Proposed GF Plan GF GIFA = 1775m²
1 : 100

CLIENT	WARWICK DISTRICT COUNCIL			
PROJECT	ABBEY FIELDS SWIMMING POOL			
TITLE	PROPOSED GROUND FLOOR PLAN			
QUOTATION DATE	SCALE	DRAWN	CHECKED	STATUS
01/06/2023	1:100	DM	JM	SI
DB3 SHEET NO.	PROVISION	REVISION		
12963 - DB3 - SP - 00 - D - A - 1001 - 53	P02			
DB3 SHEET NO.	12963 - DB3 - SP - 00 - D - A - 1001 - 53	P02

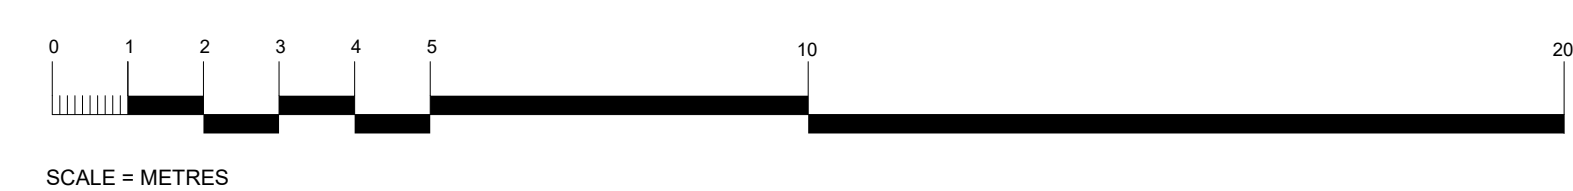
External doors relocated as a result of review of internal plantroom arrangement

Pump pit relocated to avoid clash with historic remains

Door moved due to level change externally

Ramp added due to FFL level increase

Retaining wall level increased to external levels

Retaining wall level increased to external levels

Retaining wall level increased to external levels
